MachXO 300mm Fab Transition Circuit Observations and Mitigation

Lattice is issuing this Product Bulletin to inform its customers of certain circuit observations and to supply possible mitigation strategies.

Figure 1: Marginal Signal Condition

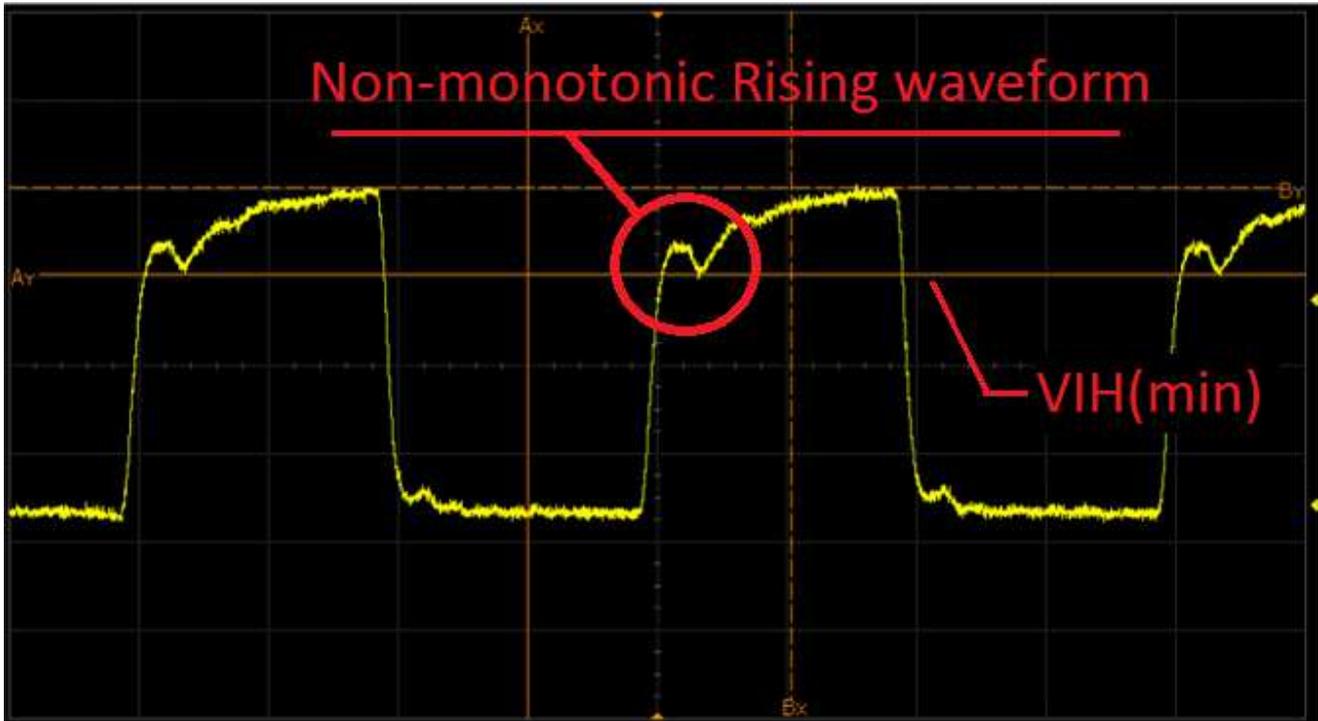
In 'marginal' circuits, transmission line effects (for example, non-monotonic rising edges, reflections and glitches) may adversely impact the output waveform. Unintentional signal transitions may migrate into the logic decision region of the downstream receiver.

A 'marginal' signal integrity condition is defined when the output signal contains a glitch or reflection resulting in non-monotonic rising edges which lay just outside the receiver's decision region bounded by $V_{IH(min)}$. See Figure 1 for an example of a marginal signal condition. Lattice supplies IBIS models for the MachXO and Platform Manager FPGA output drivers, enabling circuit designers to simulate their circuit environment prior to PCB design, or to verify actual signal behavior prior to volume production. Simulation enables the designer to choose the appropriate drive strength and termination scheme combination to eliminate 'marginal' conditions. Choosing the appropriate drive strength and termination substantially eliminates circuit susceptibility to process variations.

In designs with 'marginal' signal integrity, the use of Alternate Qualified Foundry and Mask Set MachXO or Platform Manager FPGA product can result in unacceptable increase in system failure rate. Most often, increasing the MachXO drive strength can compensate the circuit enough to move multiple signal transitions above the decision threshold $V_{IH(min)}$.

Mitigation: For customers who have reported increased system failure rates due to non-monotonic edges, simply increasing the output buffer drive strength has eliminated the issue in some cases. In other cases it was necessary to use IBIS modeling to tune the external circuit in conjunction with increasing drive strength. Note, it is necessary to re-build the MachXO JEDEC programming file using Lattice Diamond design software, or re-build the Platform Manager FPGA JEDEC file in either Diamond or PAC-Designer software, to modify the output drive strength.
